Airworthiness Directive Schedule

Components & Equipment

Aircraft Seats and Harnesses

28 August 2025

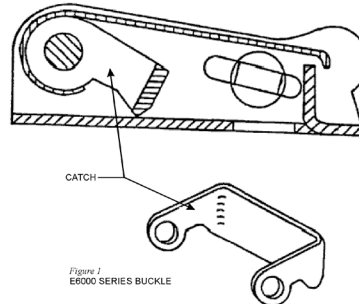
Requirement: To prevent inadvertent opening of safety belt assemblies accomplish the following:

1. Inspect all Eon Corporation TSO C22 safety belt assemblies for incorporation of E6000 buckles.
2. Remove from service all safety belt assemblies with E6000 buckles and replace with approved safety belt assemblies. Removed belts, if not destroyed, must have the TSO approval markings either permanently obliterated or removed.

Note: Buckle assembly concerned has a front cover plate which is pivoted at one end and is pulled through an arc at the other end to release the latch from the buckle. The E6000 buckle can be identified by the type of catch used. Figure 1 (following) shows the catch configuration and its location within the buckle assembly.

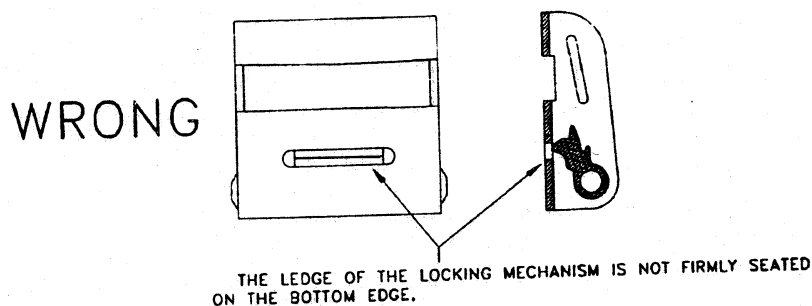
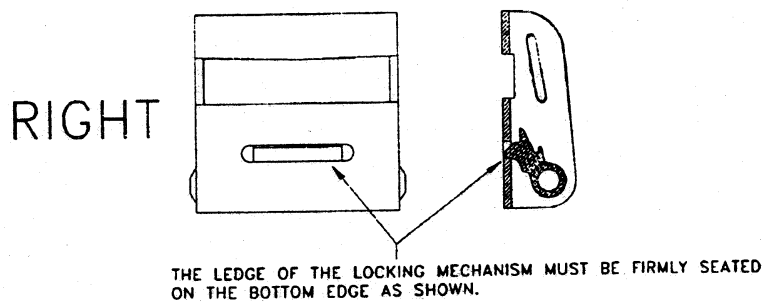
Requirement: To prevent failure of the seat restraint system due to the buckle assembly locking mechanism not engaging properly, which could result in the restraint system failing to properly secure the occupant during turbulence or landing, accomplish the following:

Visually inspect all affected seat restraint systems to determine if the locking mechanism is engaging properly per the following:

Open the lift lever of the buckle fully until it will not open any further. This will cause the locking mechanism to pivot on the pivot pin.

Allow the spring to close the lift lever slowly until the lift lever is back to its at-rest position.

After the lever is completely closed, examine the slot in the bottom of the buckle. The locking mechanism should be firmly seated against the edge of the slot as shown in Figure 1.

If the locking mechanism does not seat properly, replace the buckle with an airworthy buckle.
